<p align="center"><b>Office Action Summary</b></p>	<p><b>Application No.</b></p> <p>10/567,404</p>	<p><b>Applicant(s)</b></p> <p>IGARASHI ET AL.</p>	
	<p><b>Examiner</b></p> <p>Ernesto Garcia</p>	<p><b>Art Unit</b></p> <p>3679</p>

## **DETAILED ACTION**

Fig. 1

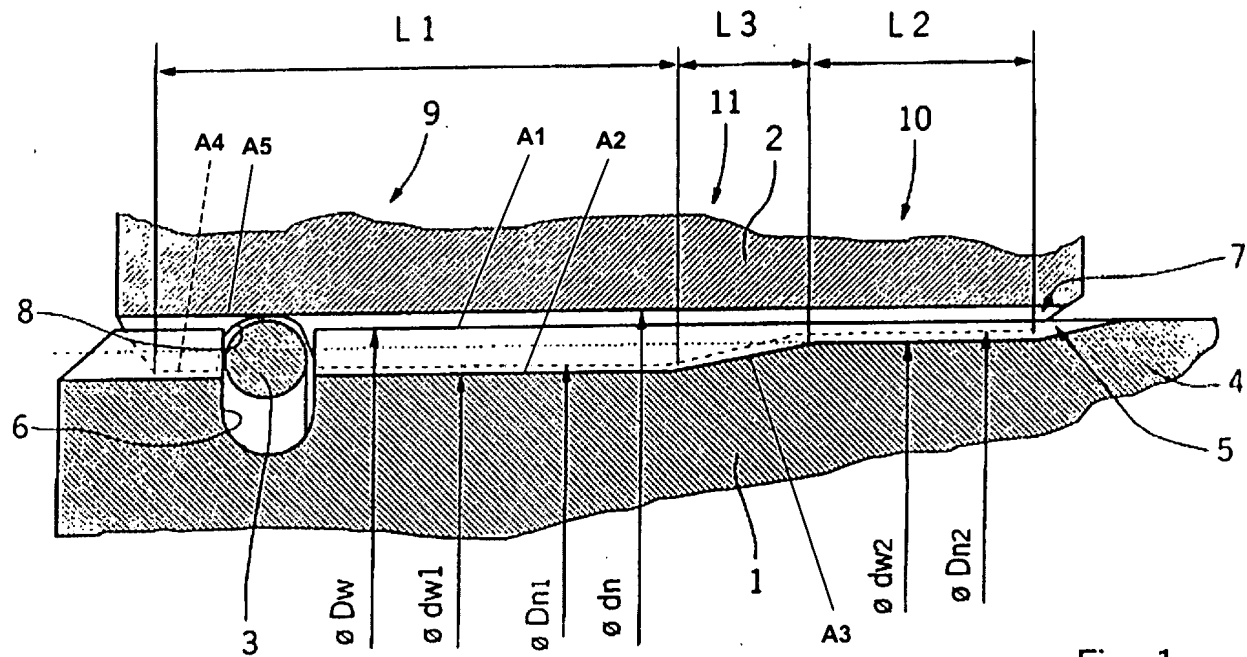
Regarding claim 11, Beigang discloses, in Figure 1, a mechanism comprising a shaft 1 and a hub 2. The shaft 1 has a shaft tooth section 5. The hub 2 has a hub tooth section 7 in engagement with the shaft tooth section 5. The shaft tooth section 5 has a straight peak A1 (see marked-up attachment) having a constant tooth thickness and a valley A2 having an outside diameter varying from an end of the shaft 1 toward a shaft shank 4 of the shaft 1. The valley A2 has a step region A3 raised toward the hub tooth section 7 obliquely at a predetermined angle. The hub tooth section 7 has a straight peak A4 having a constant tooth thickness and a valley A5. The peak A4 of the hub tooth section 7 and the valley A5 of the hub tooth section 7 have constant inside diameters from the end of the shaft toward the shaft shank 4 in an axial direction of the shaft 1.

Regarding claim 12, the step region **A3** has a tilt angle set to a value ranging from 5 degrees to 45 degrees.
